Technical Notes

Q-SYS Platform | August 2024

Updated Core Nano and Core 8 Flex firmware compatibility

Figure 1

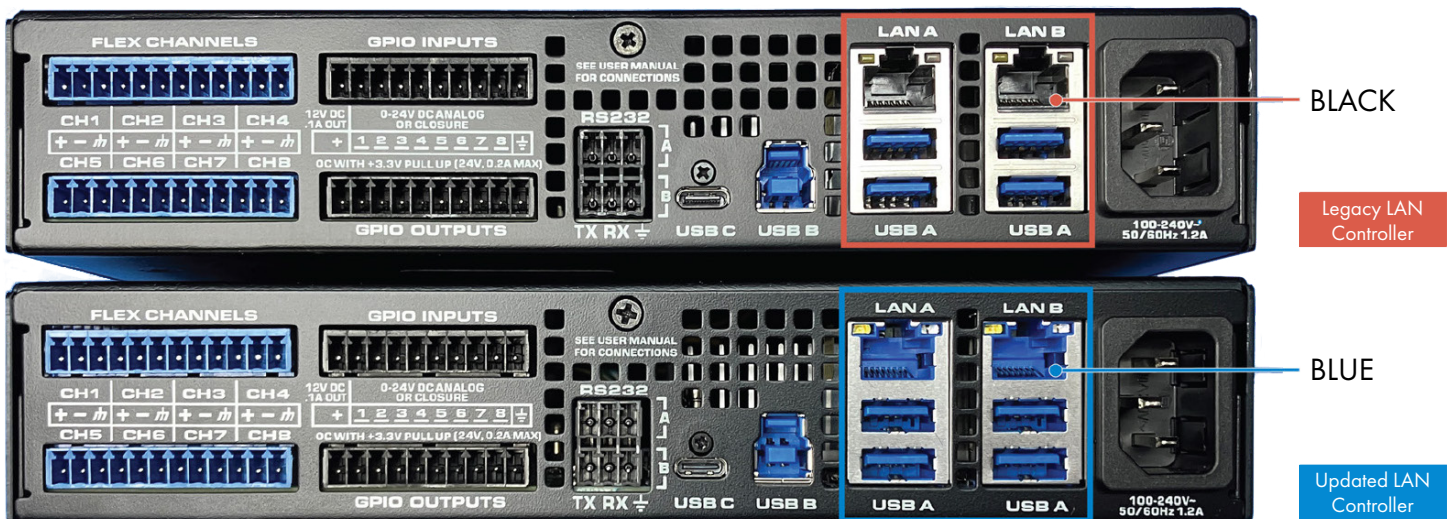
Q-SYS Core Nano and Core 8 Flex units with the new LAN controller, requiring **Q-SYS Designer Software v9.10 or later**, are manufactured with a blue plastic housing for the LAN ports*. Units with the legacy LAN controller have black plastic housing for the LAN ports (Figure 1).

The Core Nano and Core 8 Flex have a recently updated motherboard featuring a new LAN controller. This new LAN controller requires a firmware update to function properly, meaning any new Core Nano or Core 8 Flex manufactured in May 2024 or later **MUST** run **Q-SYS Designer Software v9.10 or later**. Units manufactured before May 2024 can continue to run older firmware versions.
